Date: December 8, 2004
To: Section 106 File
From: Milo L. Meacham, AIA
Project: National Law Enforcement Museum
Regarding: Meeting of December 7, 2004 regarding concerns over potential NLEM Pavilion blockage of view of Courts buildings' porticos.

MEETING MEMORANDUM

Project: National Law Enforcement Museum

Regarding: Notes of 6.23.2005 Second Section 106 Meeting

EXTERIOR BUILDING
ELEVATION DETAILS

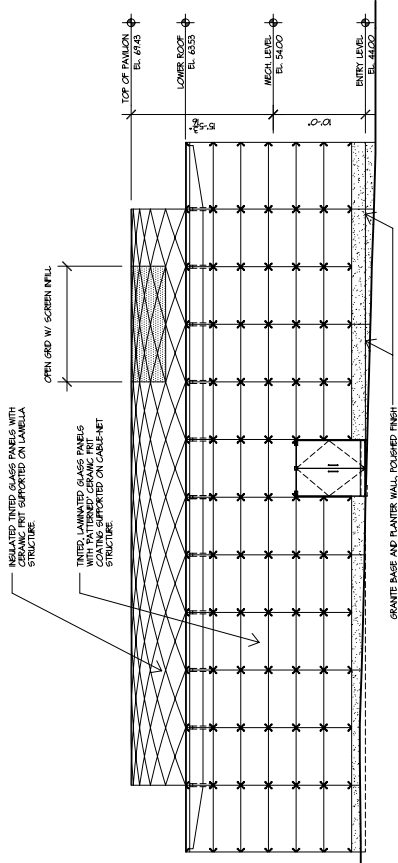
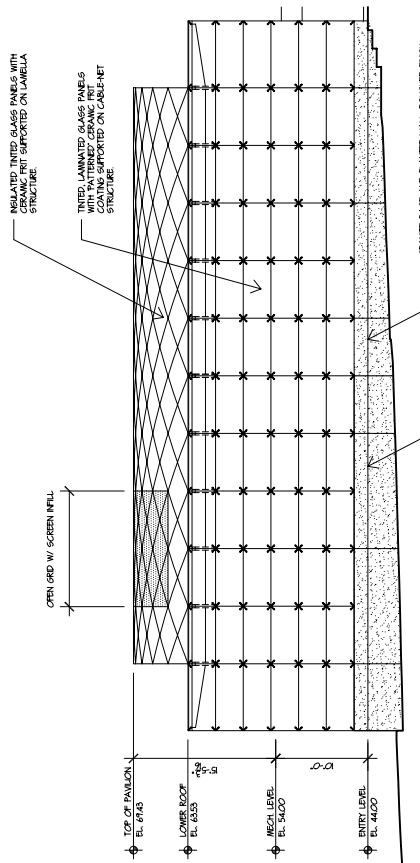
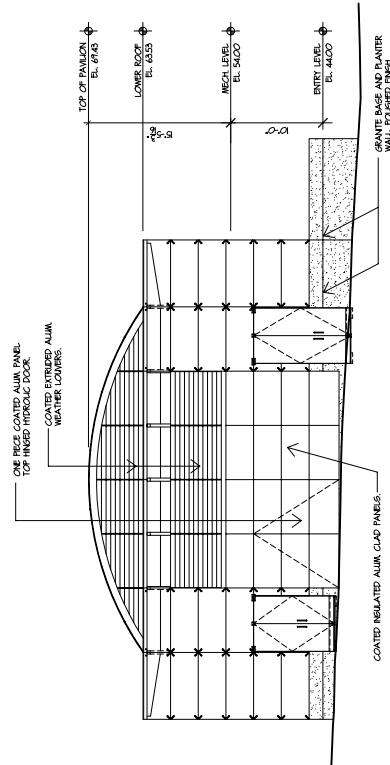
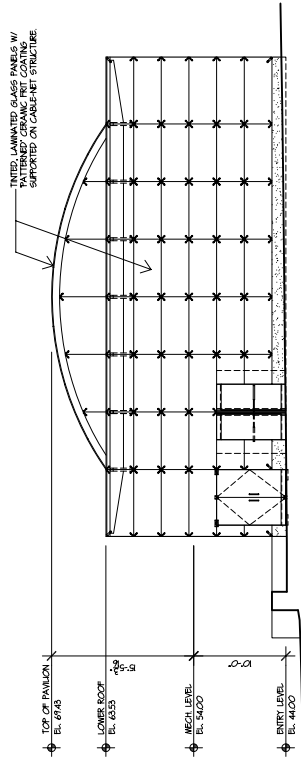
2. Mr. Maloney indicated that he still had concerns about the relationship of the south face of the Museum to the primary wall planes and porticos of the Courts buildings.

3. Mr. Meacham suggested that the “peristyles” of the Museum were the conceptual equivalent of the porticos of the Courts buildings. Mr. Maloney said he felt that the glass, due to reflections, etc. would render the volume of the pavilions as a solid. Mr. Oberlander said that in his experience on the Intelsat project, the hoped for transparency never materialized. Mr. Meacham said that in the 20+ years since the Intelsat project was built, there have been numerous advances in glass technology. Mr. Meacham said the Intelsat building was reflective glass which is only moderately transparent whereas the Museum plans to use an ultra-clear glass to achieve the desired transparency.

Concept Design Plan

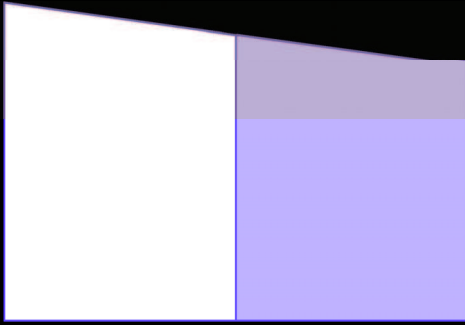
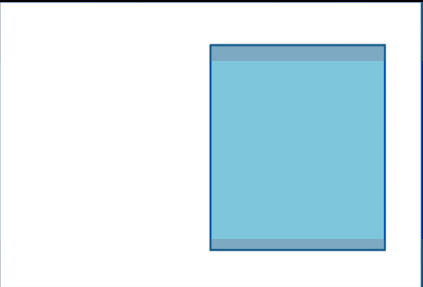
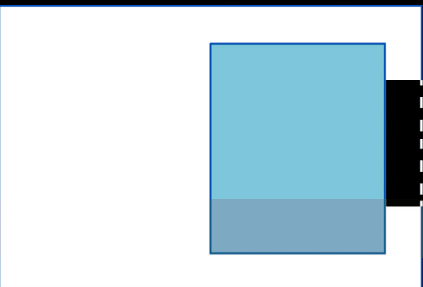
1. Mr. Meacham presented the current (Schematic Design Update) plans and elevations for the National Law Enforcement Museum noting that the design concept had received concept approval by the U.S. Commission of Fine Arts in October of 2004. Mr. Meacham also reminded the attendees of the approved “box within the (glass) box” design concept for the Museum’s pavilions wherein the north wall of the inner box was to approximately align with the primary wall plane of the adjacent Courts buildings. Mr. Meacham also presented “Critical Plaza Elements” plans for each of the Museum levels which indicated code required elements in red and required program elements in pink. Mr. Meacham explained that these elements could not be reduced further and comply with code and meet the Museum’s program.

4. Mr. Maloney indicated that he “...thought the pavilions were as small as they could be” and that he thought the solution might be to get the Courts to agree to let the NLEM move the pavilions to the South.
5. NLEM/DBA indicated that they would take Mr. Maloney’s comments under advisement

EXISTING NORTH ELEVATION

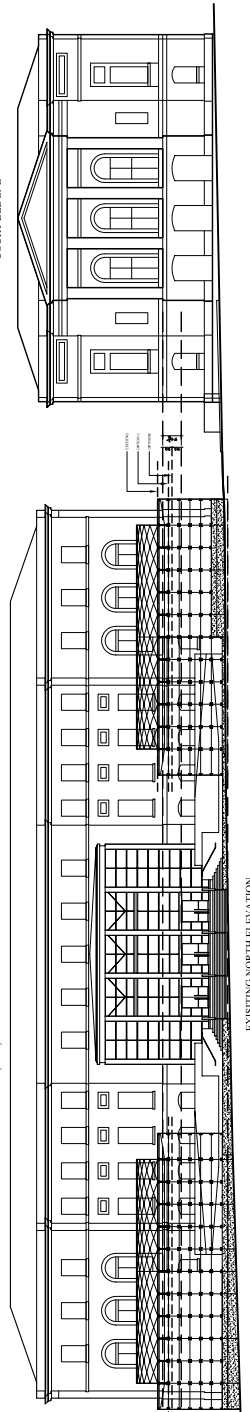
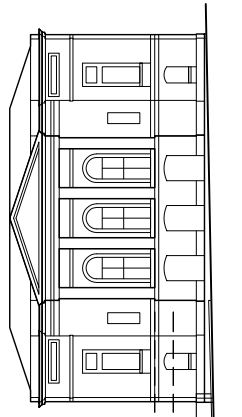
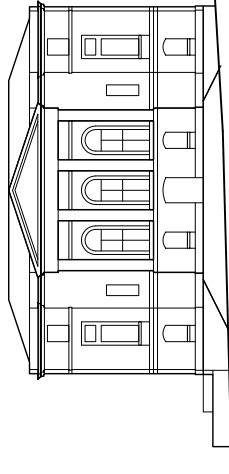
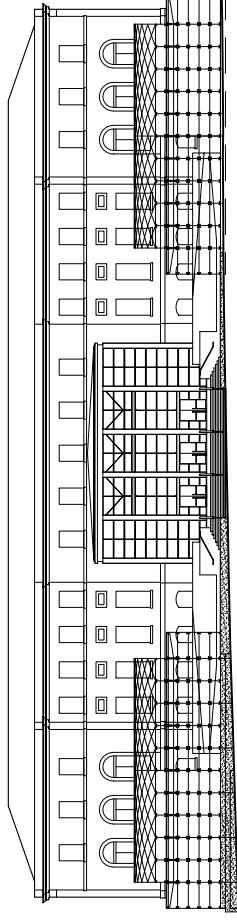
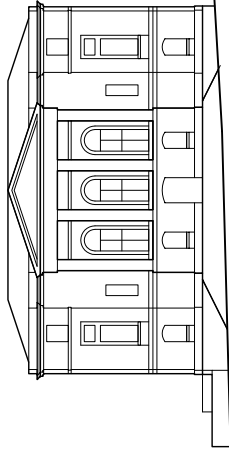
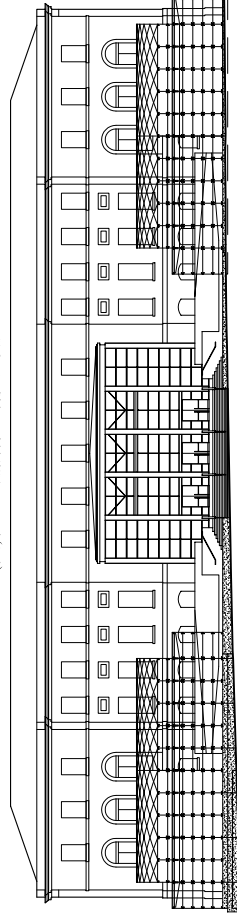
-
1. Davis Buckley began the meeting saying that in response to the discussion of last meeting about the idea of lowering the height of the peristyles of the pavilions, DBA had studied two options for that basic idea: one, (Option A) which simply eliminated the upper course of glass (approximately 3'), and one (Option B) which made the height of the peristyles approximately at the elevation of the mid-point between the top of the West Court Building (E) portico plinth and the top of the East Court Building (C) portico plinth.

2. M. Meacham presented an "Existing North Elevation" drawing (attached) that has the current north elevation (as shown in the schematic design update completed recently.) Also on the same drawing, is a copy of the same elevation with lines and other annotations added showing the heights of the top of the West Court Building Portico Base, the top of the East Building Portico Base, and the mid-point elevation between the two portico bases. The annotations indicate "Option A", approximately 3' below the top of the current peristyle design and "Option B", at the mid-point between the high (west) and Low (east) Court building portico bases.

3. Mr. Meacham then presented another drawing with two alternate north elevations, "Option A" and "Option B". A new animation was screened (still views attached hereto) showing the new, lower, configuration of the peristyles, per Option A, alongside the previous animation of the current (Schematic Update) scheme shown previously. Mr. Meacham indicated that DBA preferred "Option A" over "Option B" because it had better proportions. Mr. Maloney concurred with that preference. .
